CS Memorandum No. 1400

CMB Meeting Minutes #117

REFERENCE Project No. M544.1, Contract No. 149 Task 1-8.02
Final Design

SUBJECT: Configuration Management Board Meeting # 117 – Rev. No. 0

**DRAWING No. CS 1252 - 016
COR 051**

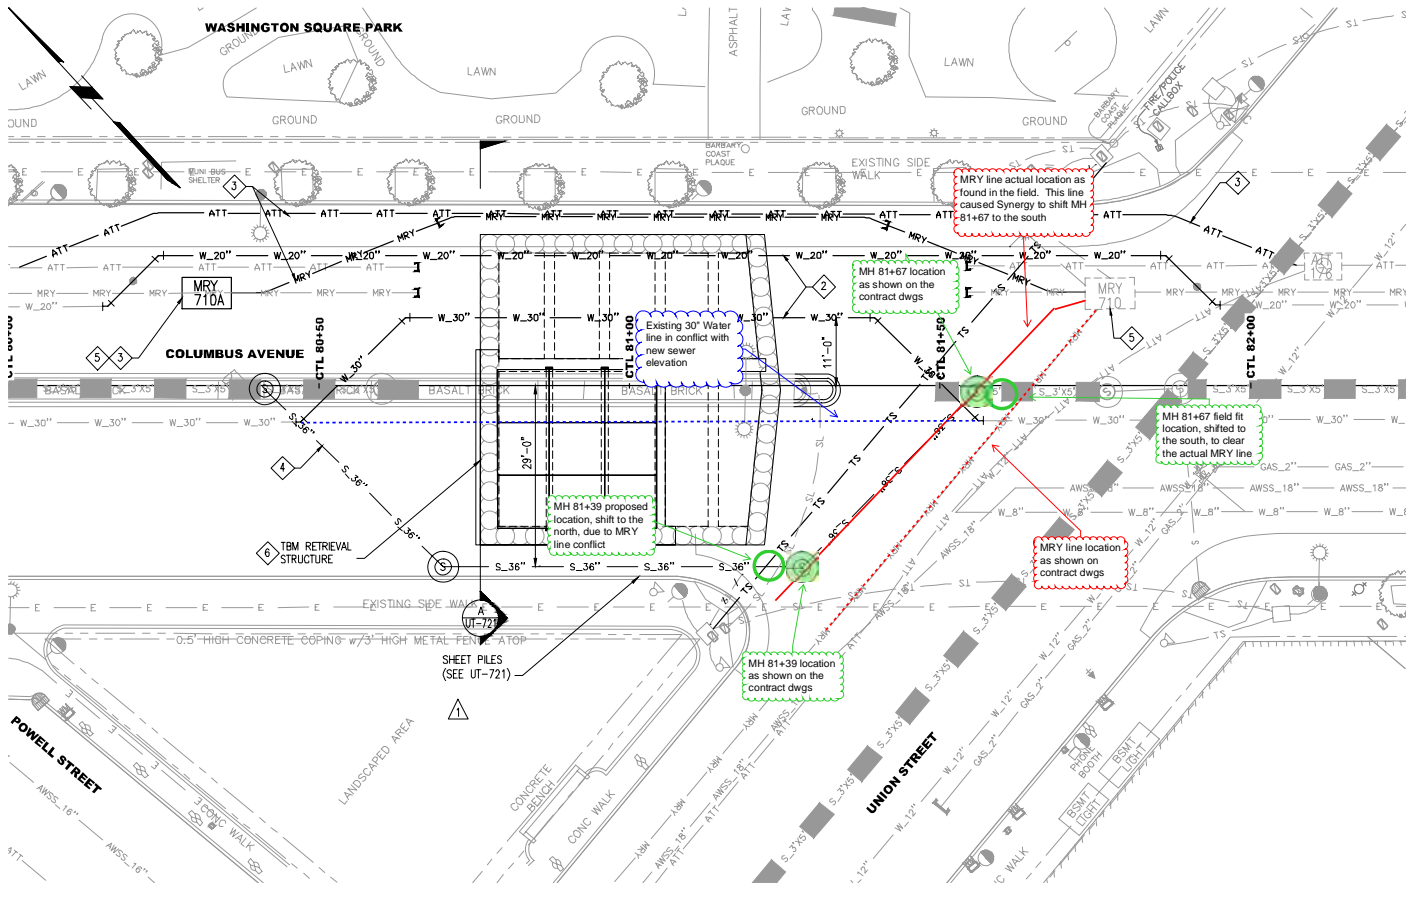
The (E) MRY duct bank was found in the field to be approximately 8' to the north of the location shown on contract drawing UT-701 rev.1. See attached drawing CS 1252 -16. The MRY duct bank ran directly through the proposed 36" sewer alignment from MH 81+39 to MH 81+67 and directly through the proposed MH 81+67 and MH 81+39 foundation locations. As a result of this conflict the Contractor's crews hand excavated around the MRY concrete duct bank and shifted the MH 81+67 to the south by approximately 2'.

MH 81+39 has not been constructed yet, but will have to be shifted to the north by approximately 2' as shown on drawing CS 1252 - 016. It is estimated that there will be no additional cost for the shifting on MH 81+39 because Synergy is aware of the actual MRY duct bank location.

PROJECT NO.	1252
DRAWING NO.	CL-18001
DRAWING NO.	UT-701
SHEET NO.	1

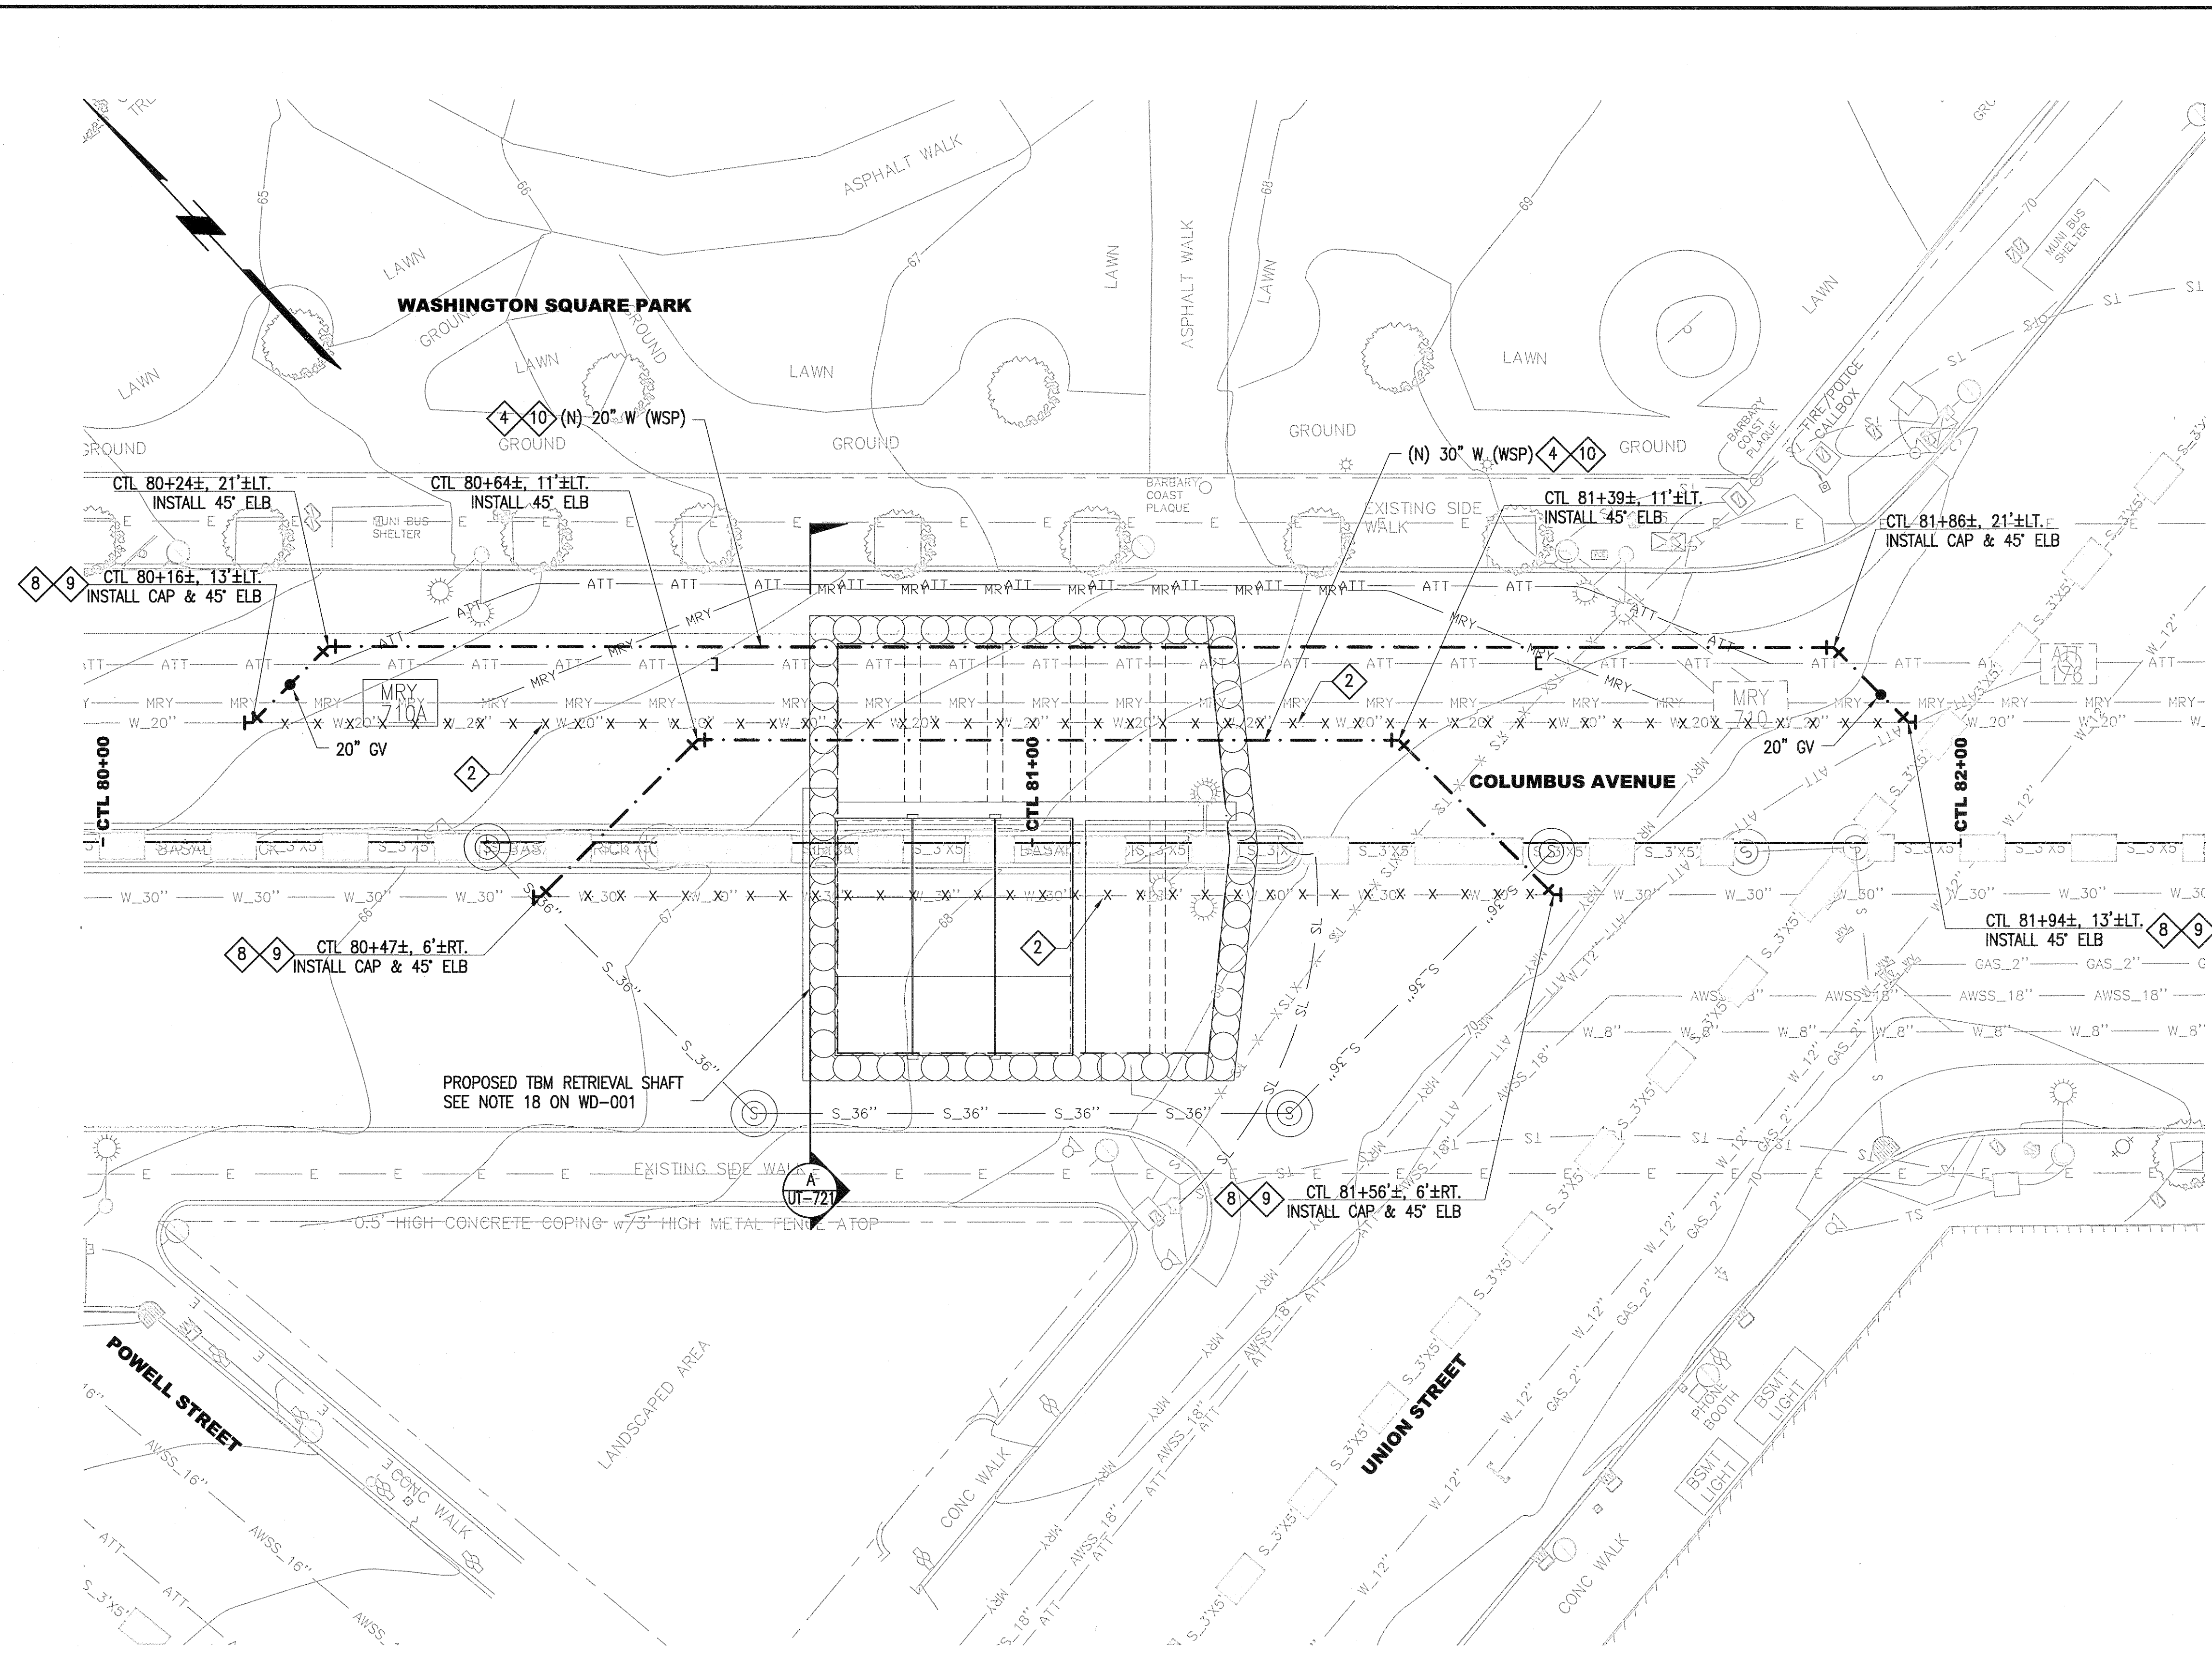
Facts: The existing (E) 3'x5' sewer and the (E) 30" low psi water line are shown on contract drawing UT-701 rev.1 to share the same invert elevation. The actual invert elevation for each utility was field verified and the 30" low psi water line was found to be approximately 2' deeper than the invert elevation shown on the contract drawing. See attached drawing CS 1252 -15 which shows the actual invert elevations encountered. If reconstructed at this elevation the proposed water line, as shown on contract drawing WD-701 rev.0, would be in conflict with the proposed 36" sewer being constructed as shown on contract drawing SW-3 rev.1. As a result of this conflict the Contractor's crews lowered the MH 81+67 invert elevation by approximately 2 feet. The lower MH invert location will result in additional resources and excavation required to install the proposed sewer main from MH 81+39 to MH 81+67.

Contract drawing UT-701 rev.1 depicted the concrete MUNI duct bank to be located 8' away from the actual location found in the field. The field location resulted in the Contractor having to shift (2) MH locations; one was excavated when the differing site

CONTRACT NO. 1252
 DRAWING NO. SW-3.1
 FILE NO. 91,618
 REV. NO. 0

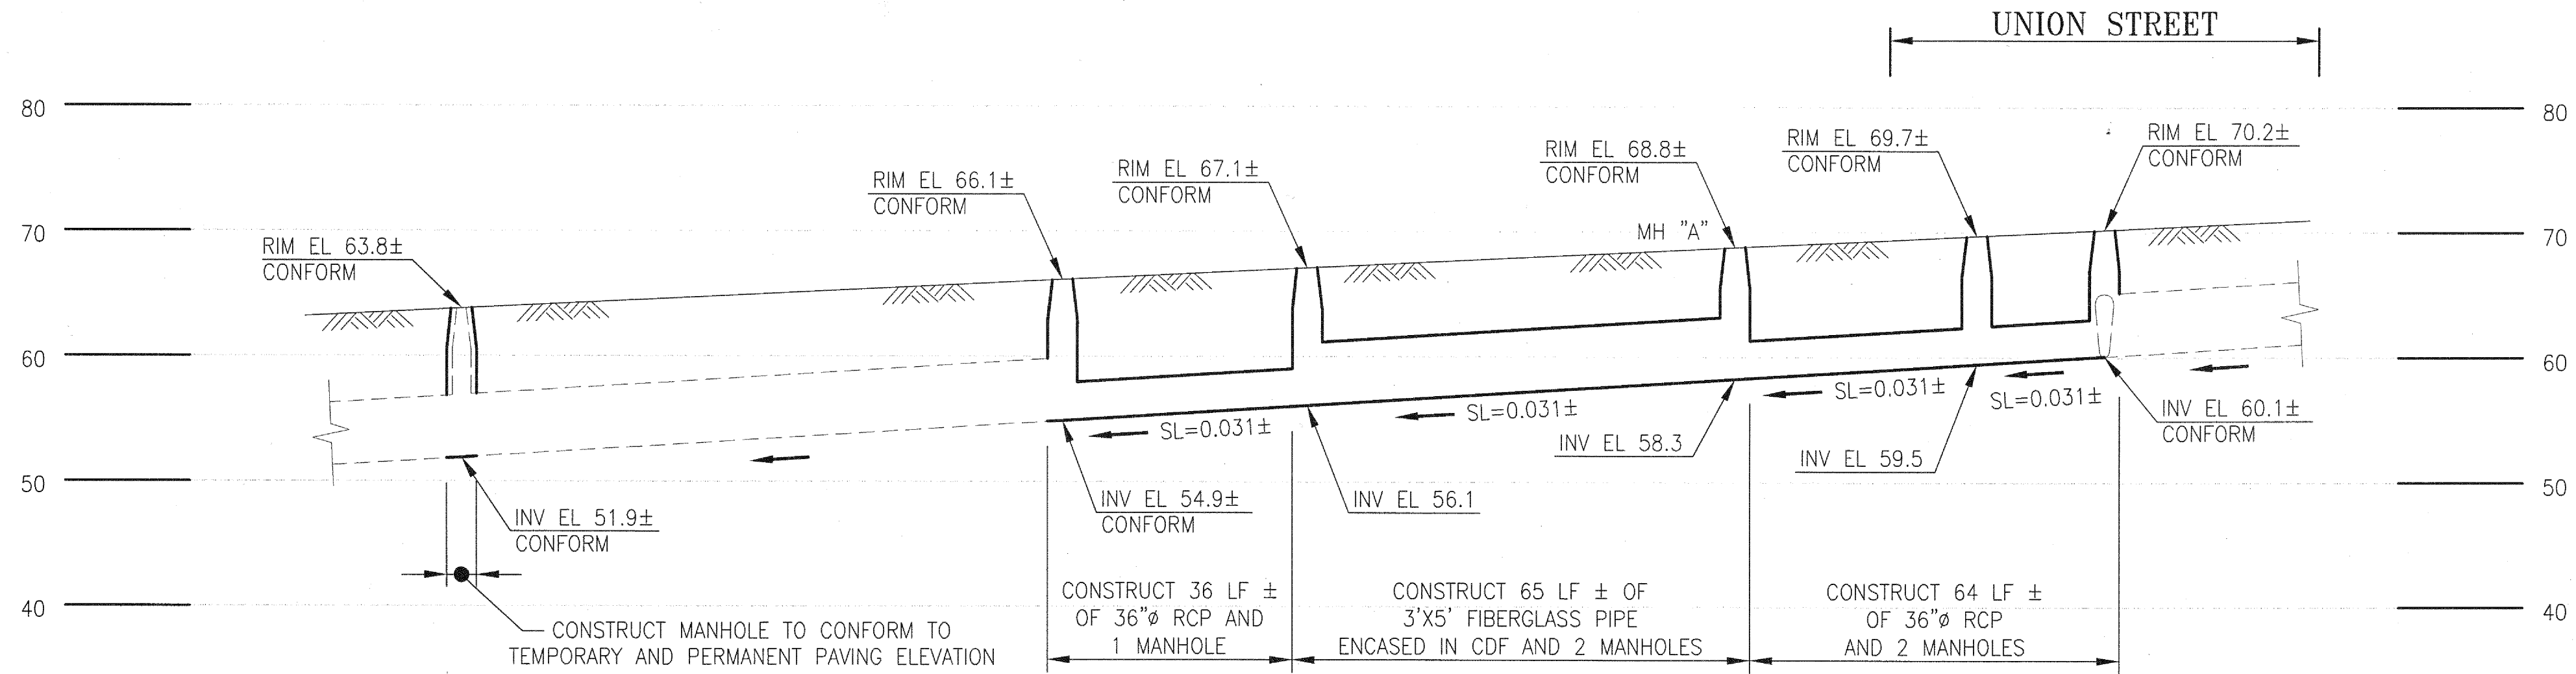
The actual invert elevation of MH 80+41 was found to have a 1' higher invert elevation than shown on contract drawing SW-3.1 rev.0. The higher invert location will result in less resources and excavation required to install the proposed sewer main from MH 80+41 to MH 80+70.

**DRAWING NO. CS 1252 - 021
COR 073**

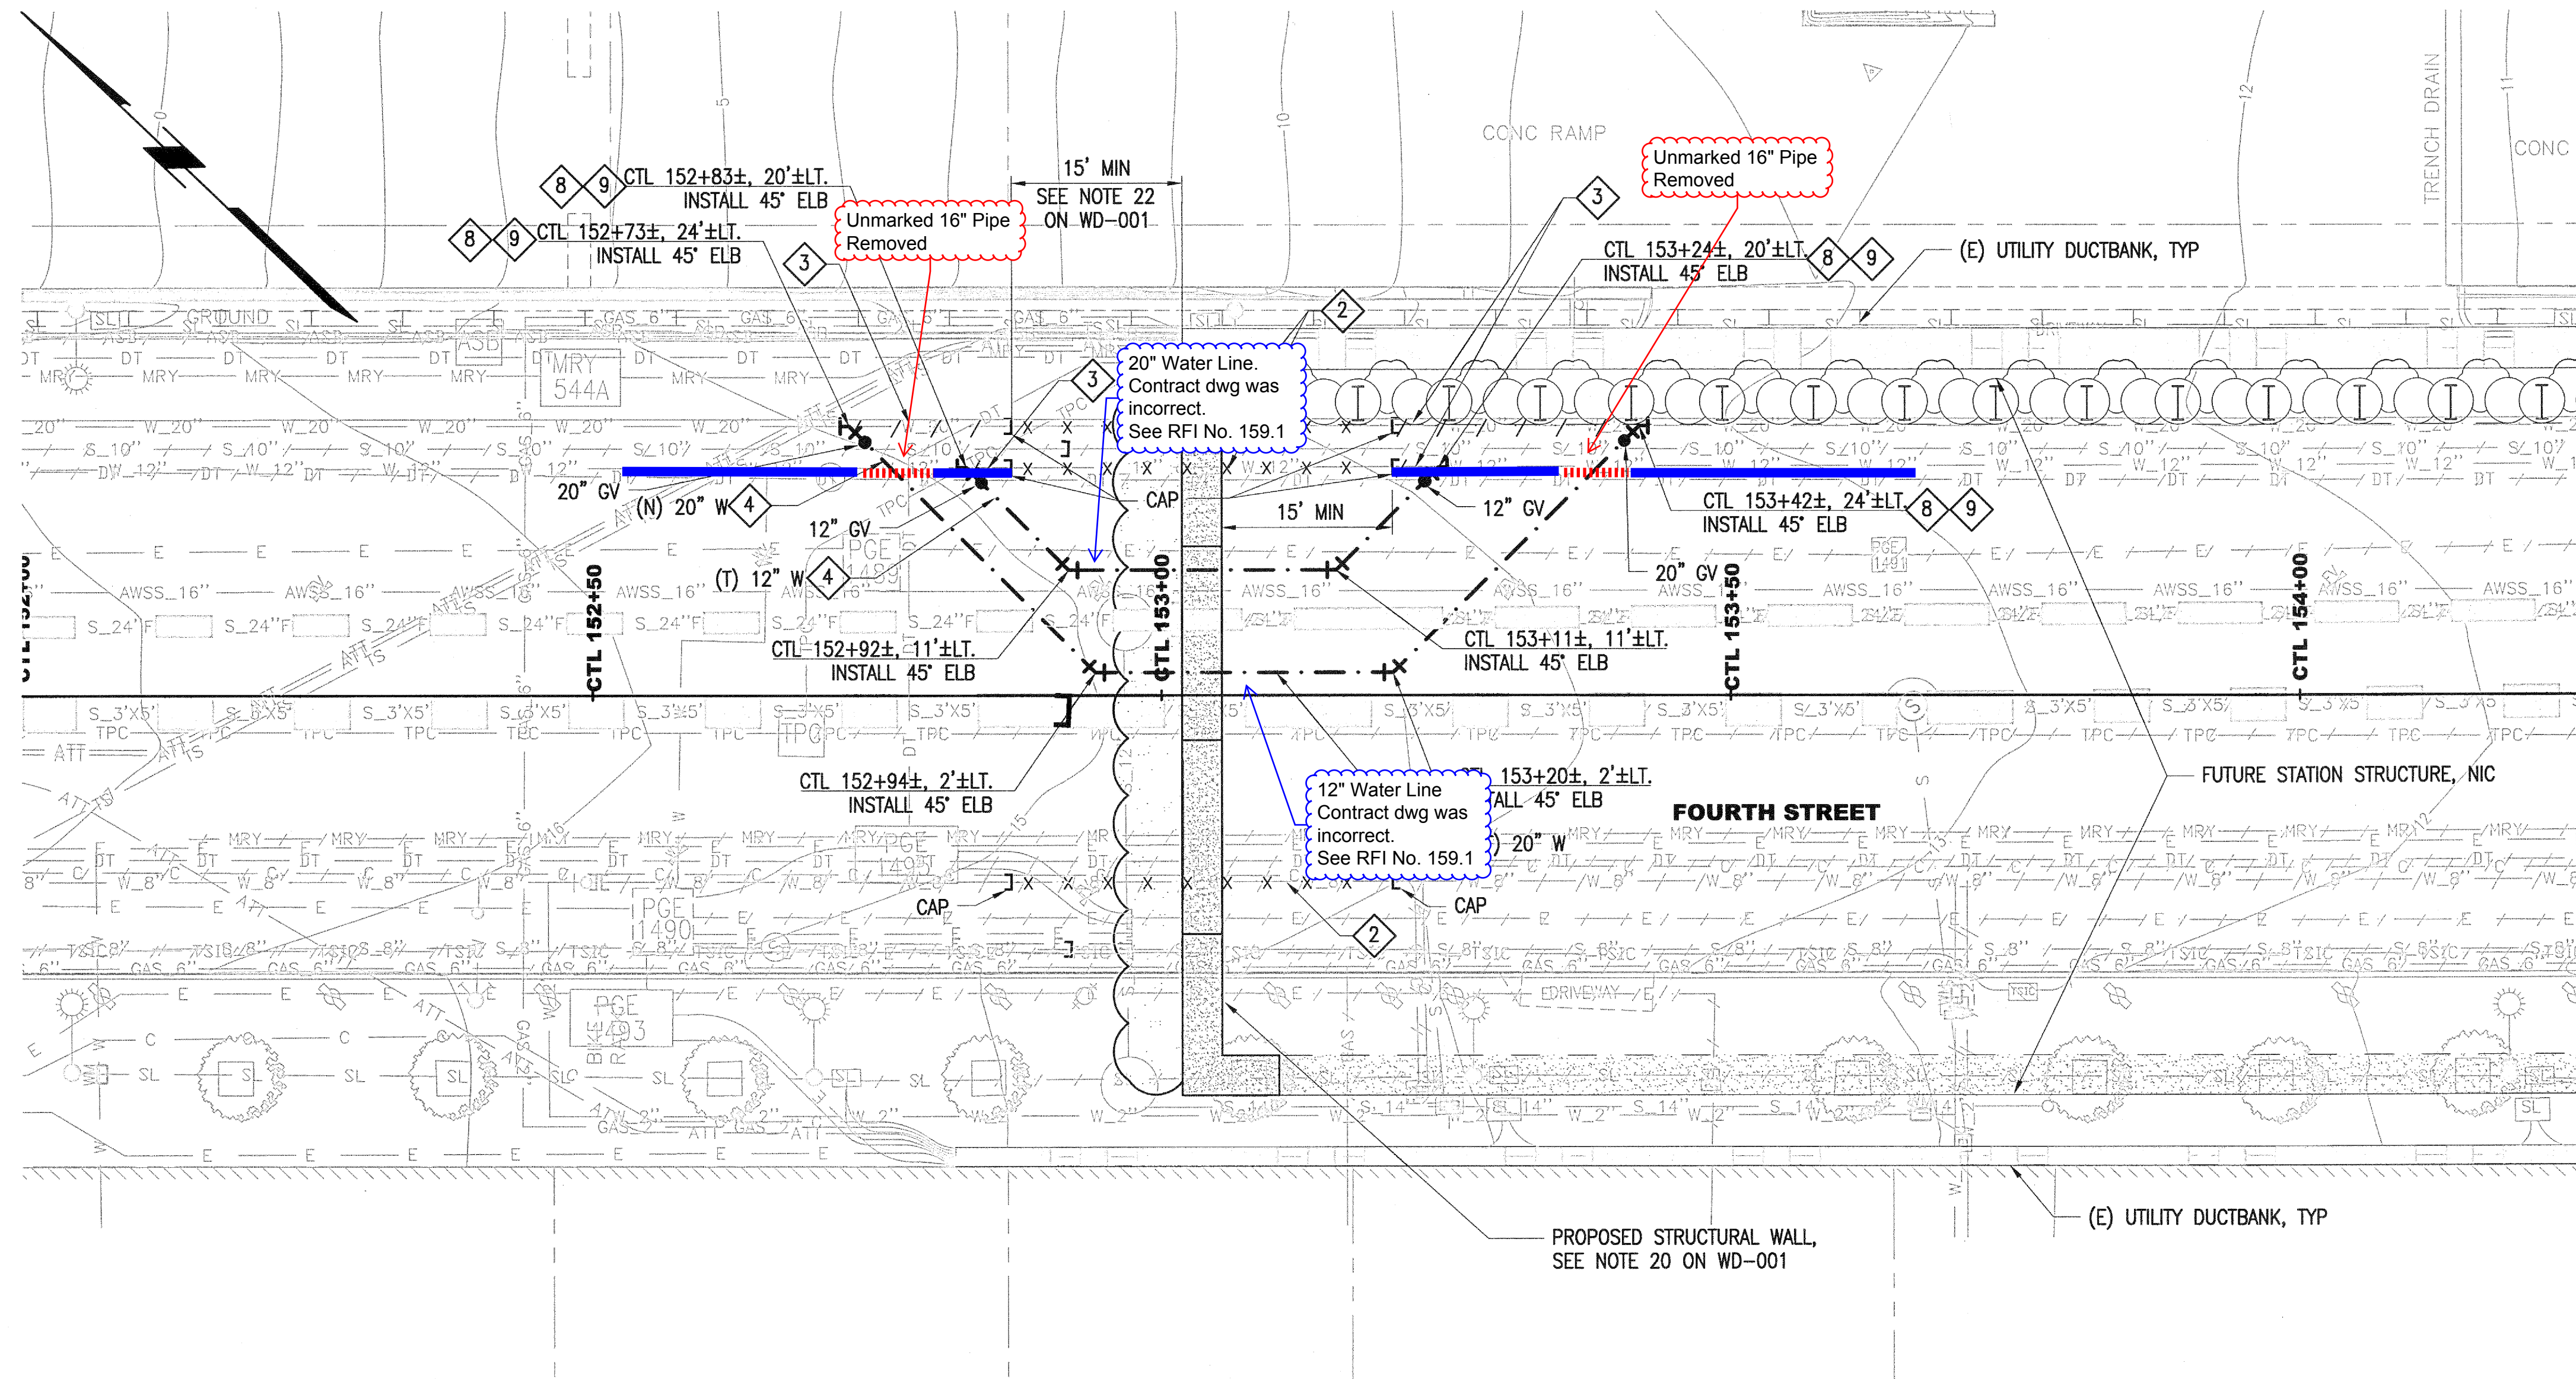
Facts: On February 14th, 2013 the Contractor encountered an abandoned 16" pipe located in the trench of the proposed 12" low pressure waterline. The 12" waterline could not be installed until the abandoned 16" pipe was removed. The 16" steel pipe was removed at the 12" water tie-in locations at the north and south side of the Moscone northeast headwall. See attached Drawing CS 1252 - 21.

Justification: The contract drawings, specifically WD-402 rev.0 and UD-402 rev.0, did not show the abandoned 16" pipe which constitutes a differing and unforeseen site condition. The 16" pipe was at the same elevation as the proposed 12" waterline and therefore needed to be removed. SFTMA inspectors have verified that additional labor and equipment resources were required to facilitate removal of the 16" abandoned pipe.

Recommendation: Accept justification of Merit for COR 073 – Moscone Unknown 16" Pipe Removal @ North Headwall. There is no time extension requested or recommended for this work.
